ADDENDUM NO. 2

MLK ELEMENTARY SCHOOL WELLNESS CENTER BAKERSFIELD CITY SCHOOL DISTRICT

Project No.: 5527 DSA File No. 15-6 DSA App No. 03-122605 December 19, 2024

S6.01

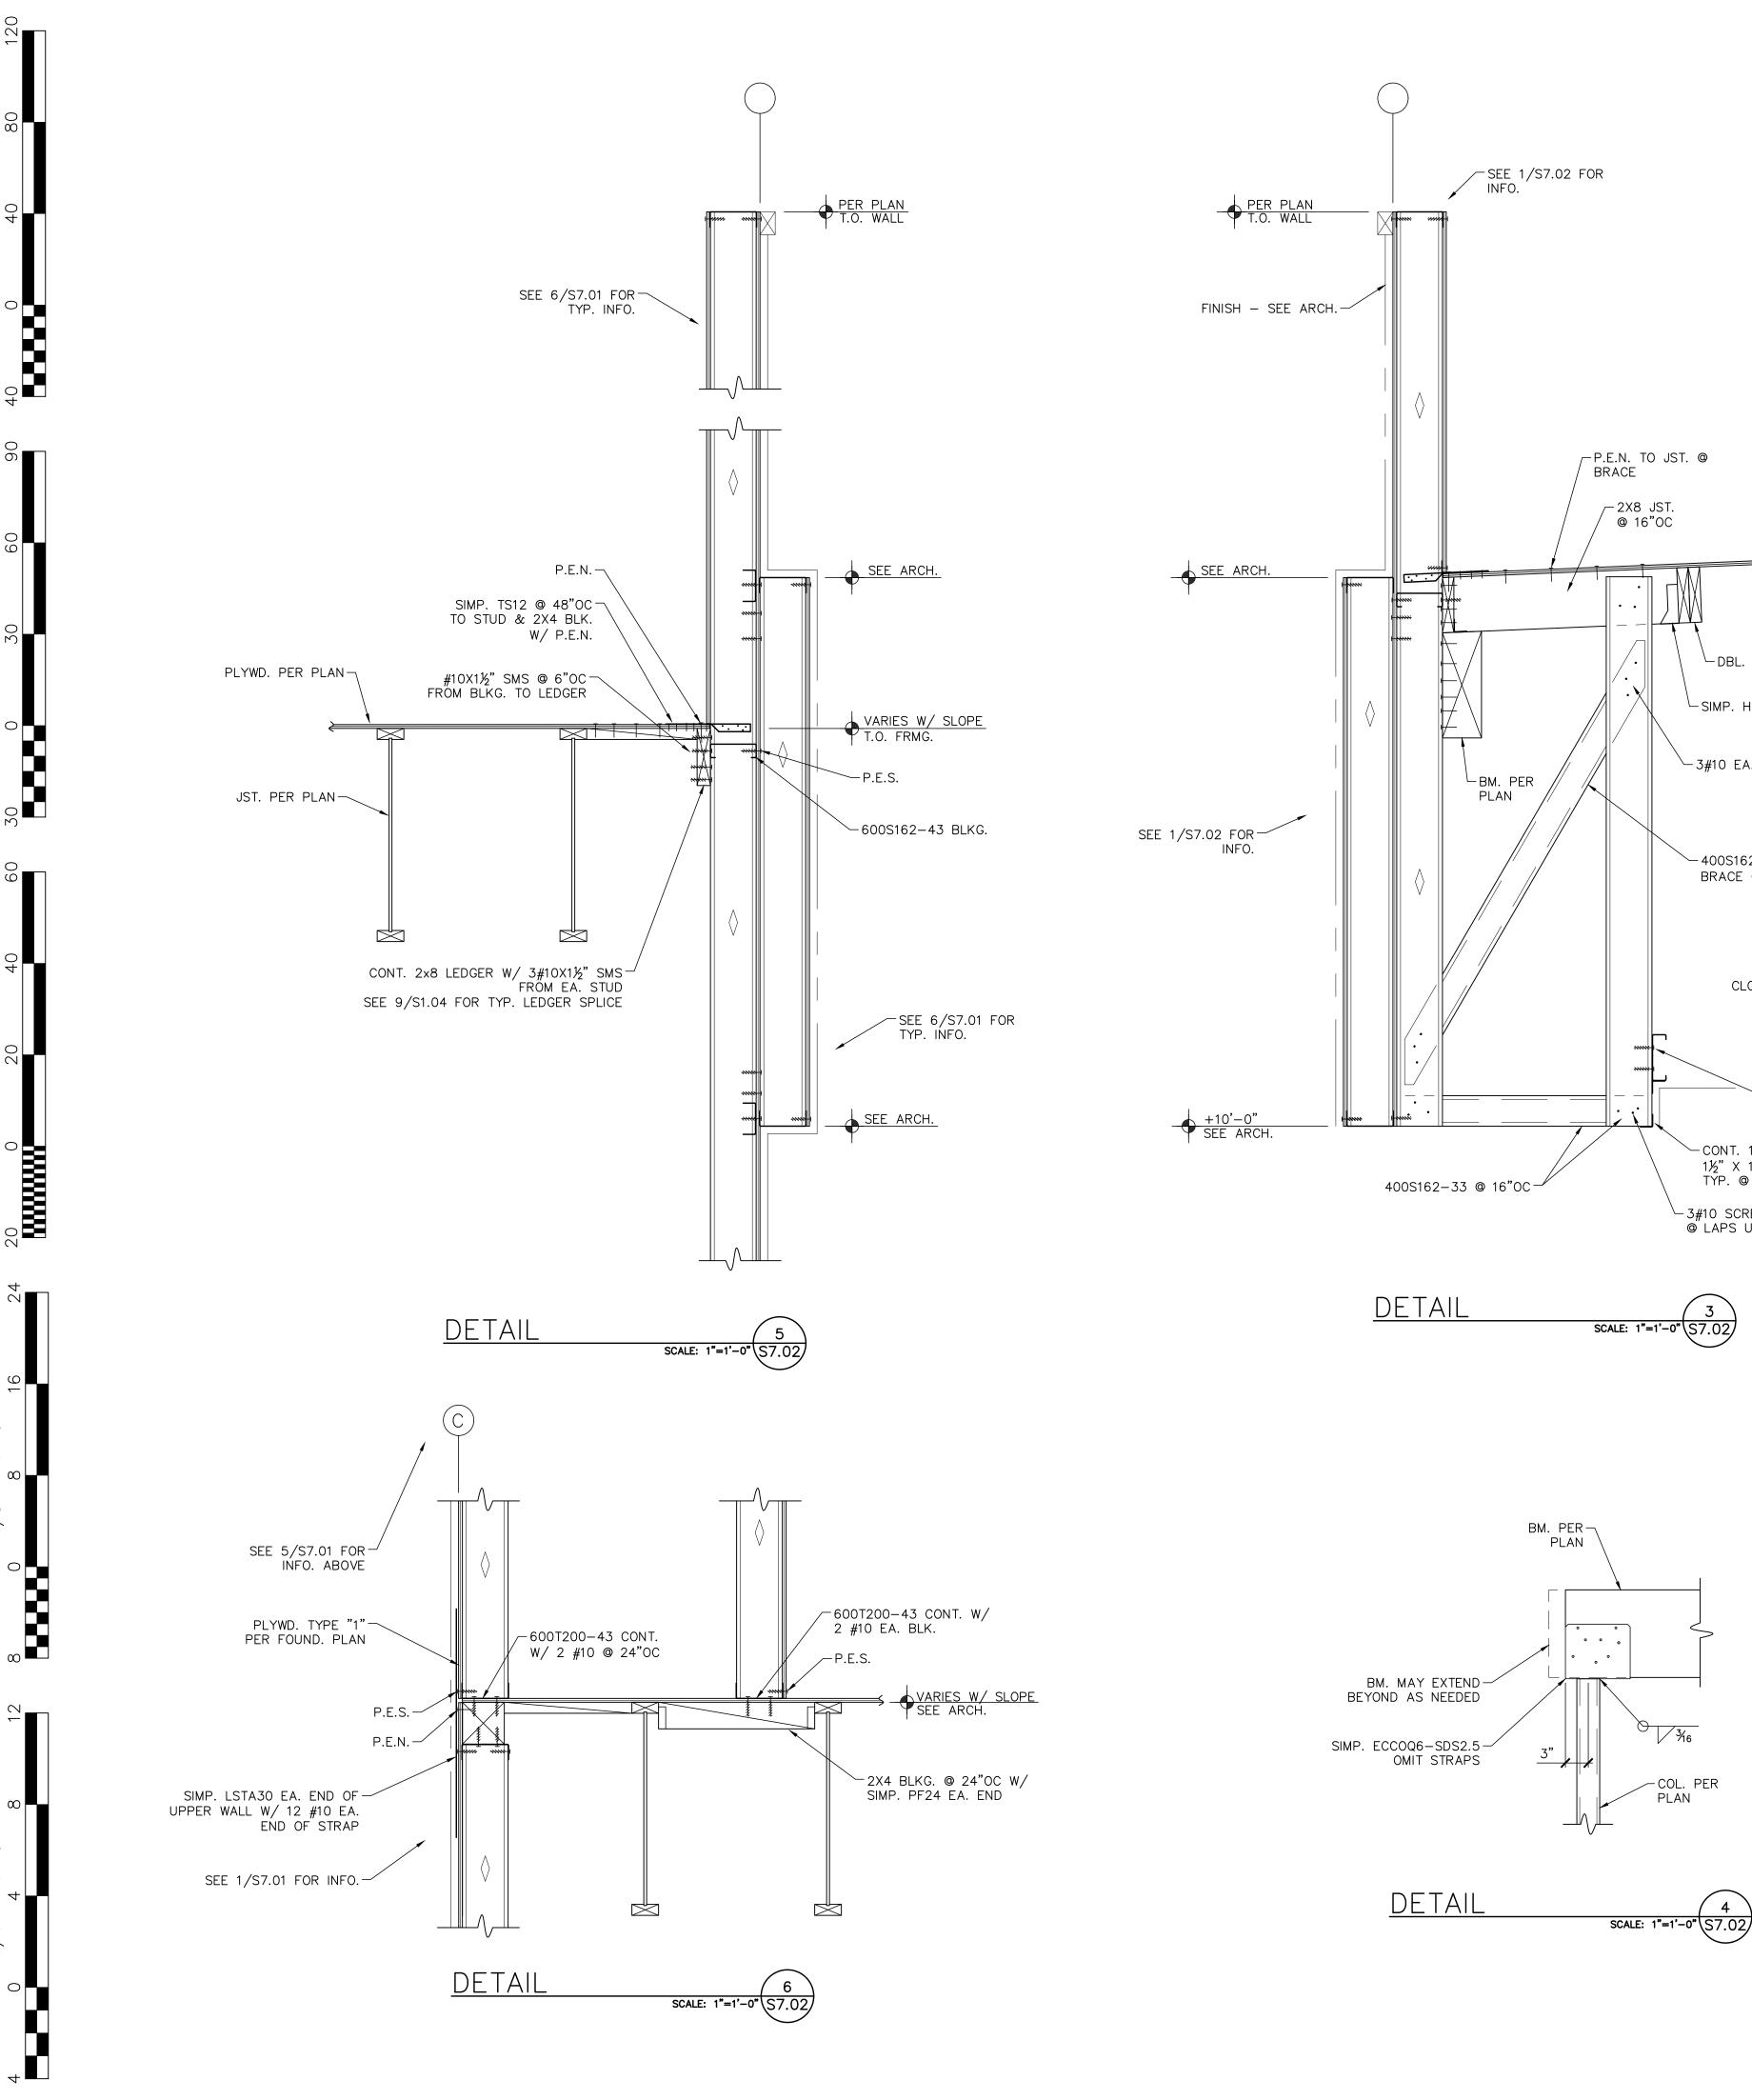
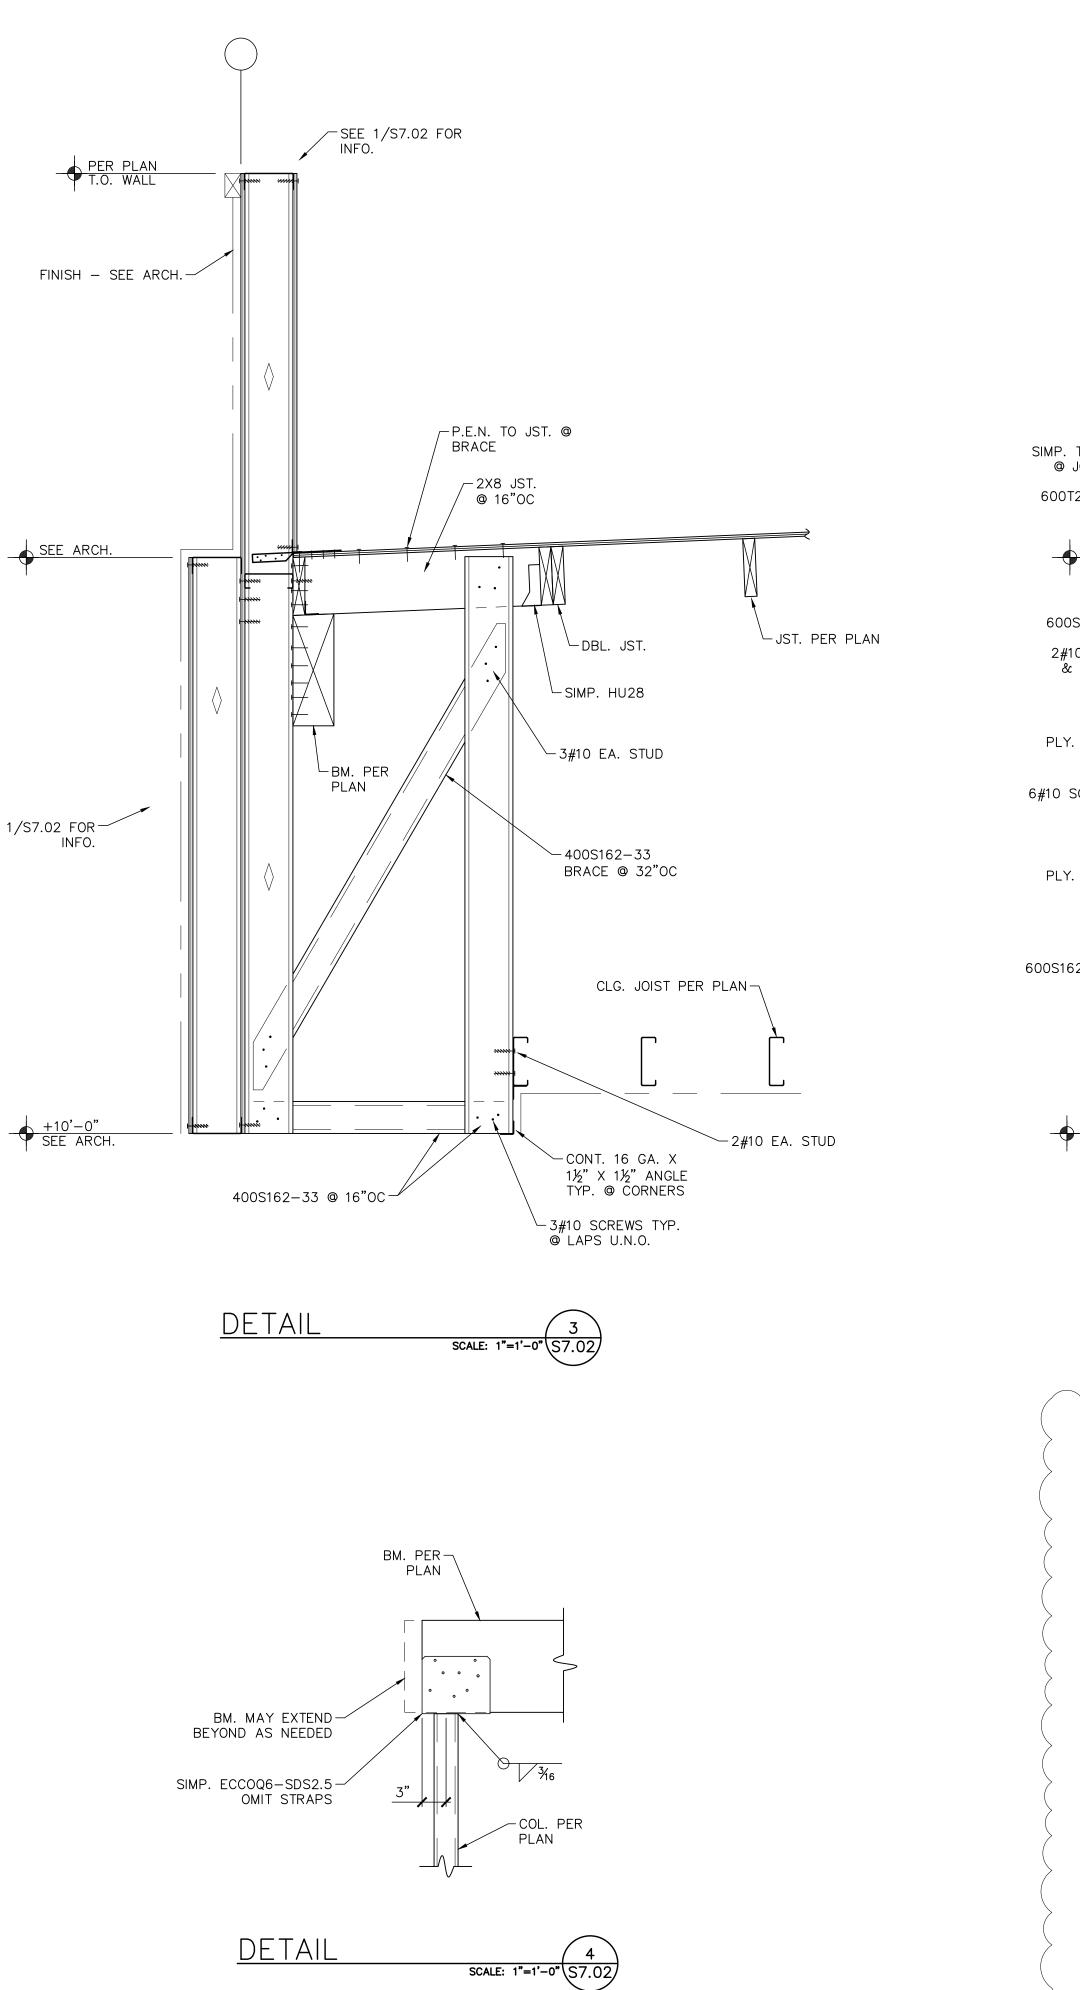
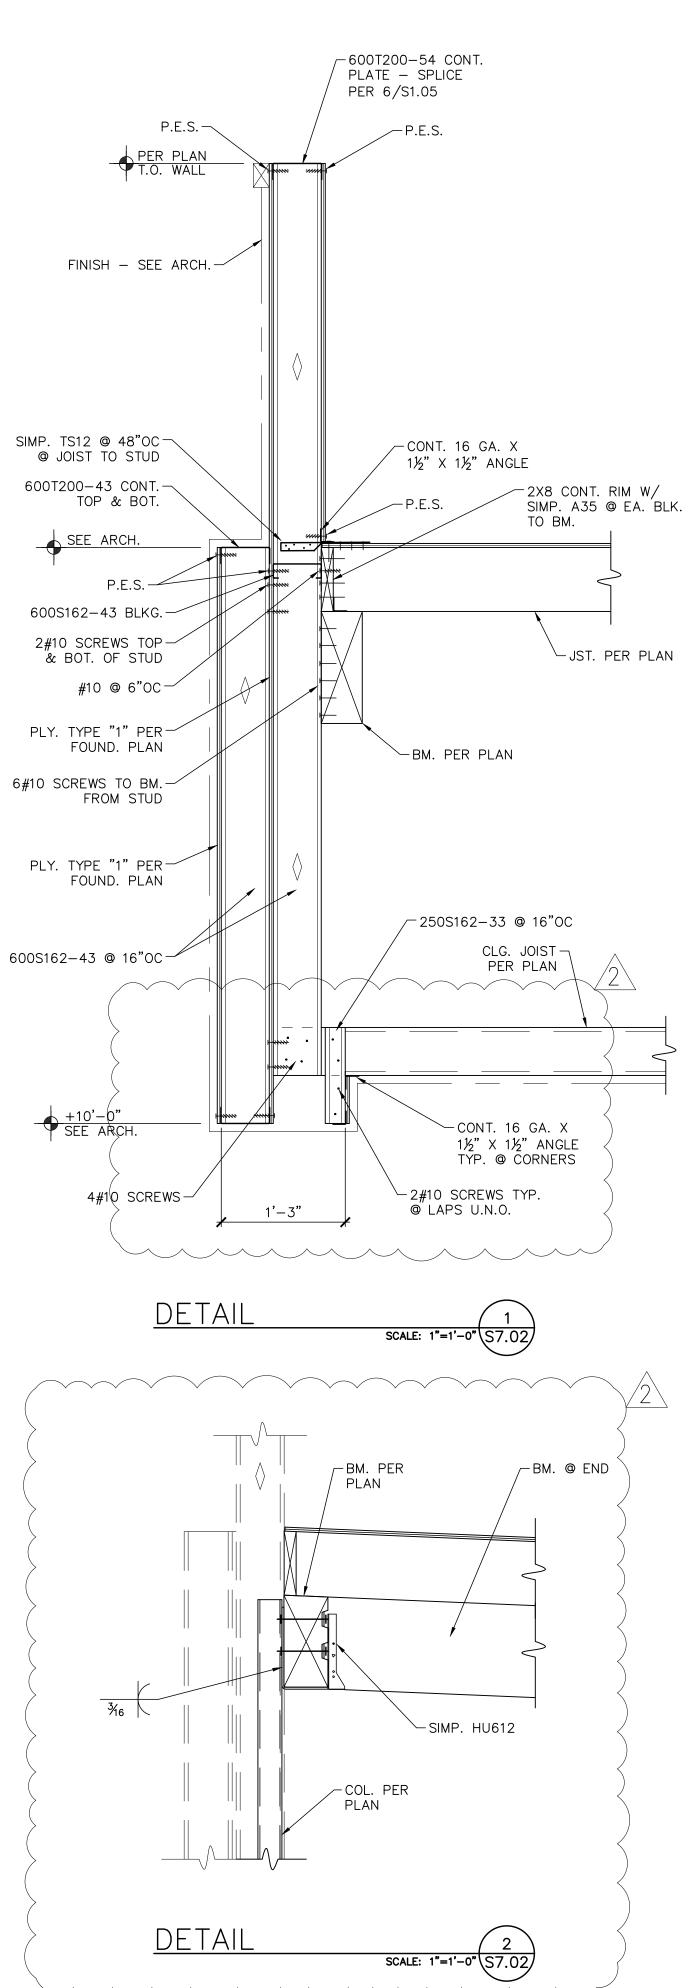
- 1. Dimensions for columns and pilaster have been changed.
 - 2. Location of mechanical units has changed.
- **2-24 DRAWING, SHEET S6.01 FOUNDATION DETAILS:** Note the following changes (See S6.01 addendum 2 drawings):

- 1. Details 6, 7 and 8 the column pocket depth has bene changed to 6".
 - 2. Detail 5 concrete ledge has been added for the block veneer.
- **2-25 DRAWING, SHEET S7.02 FRAMING DETAILS:** Note the following changes (See S7.02 addendum 2 drawing):

S7.02

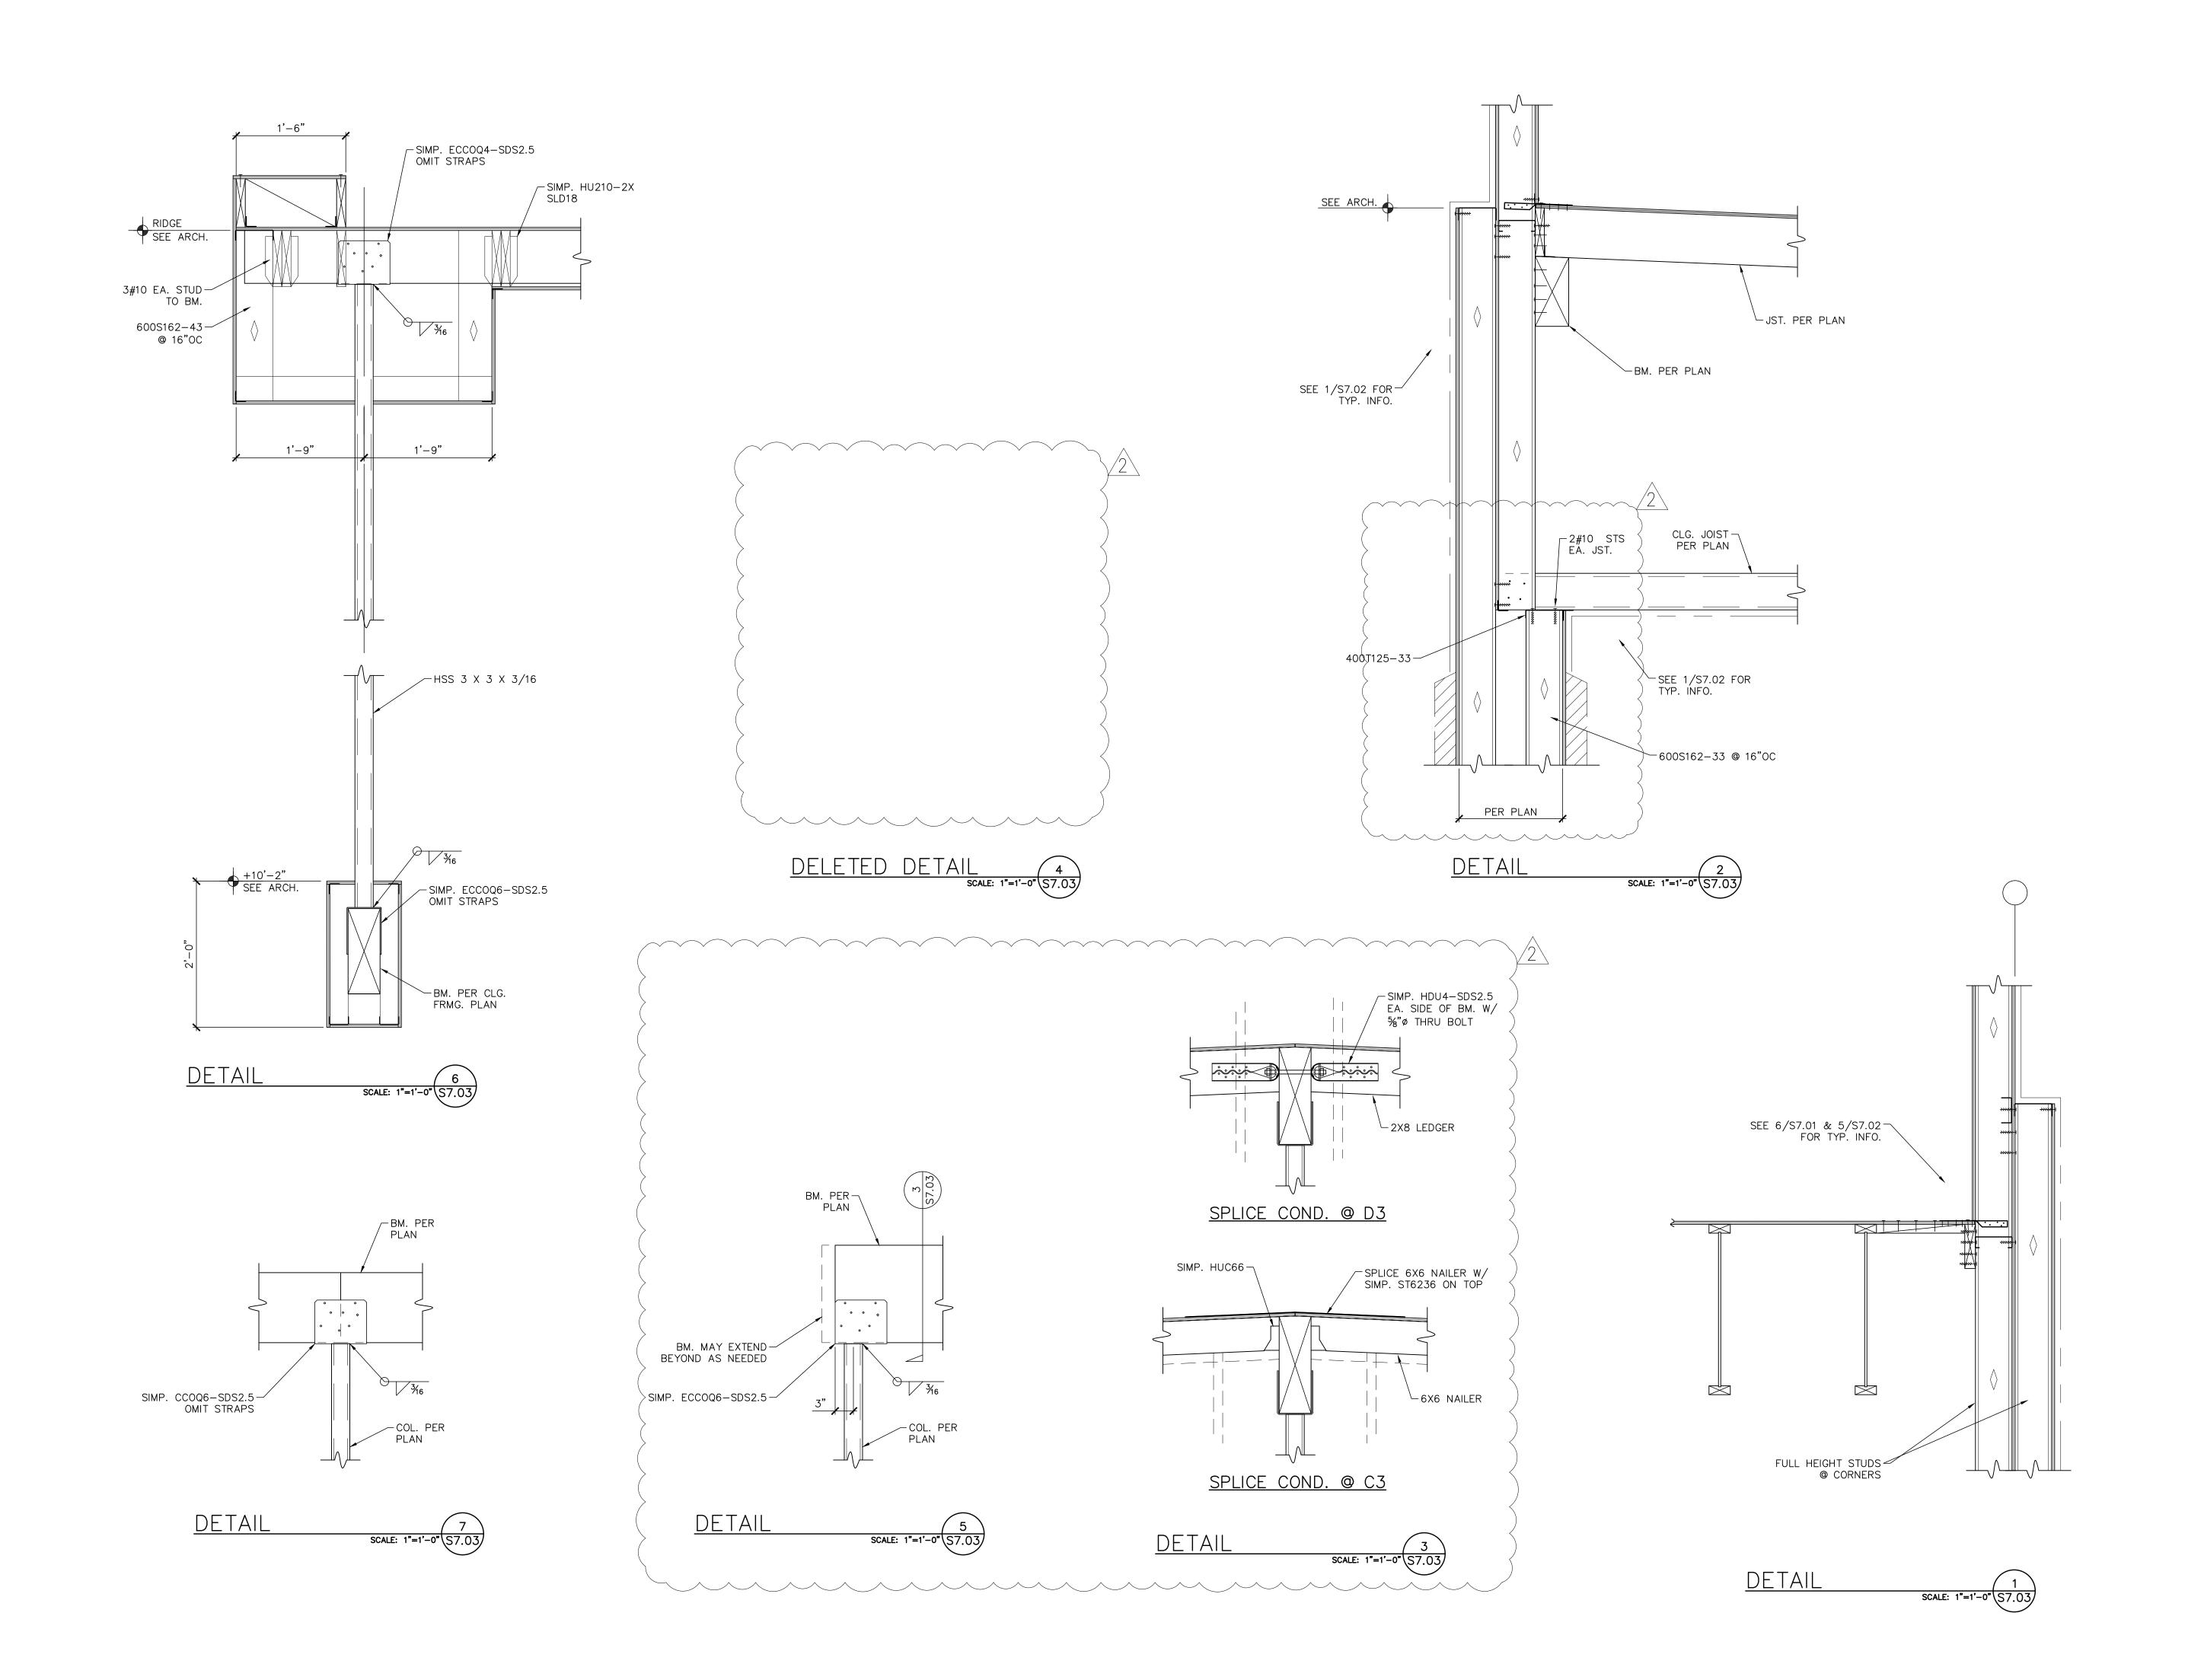
- 1. Detail 2/S7.02 has been added.
 - Detail 1/S7.02 has been modified.
- **2-26 DRAWING, SHEET S7.03 FRAMING DETAILS:** Note the following changes (See detail S7.03 addendum 2 drawings):
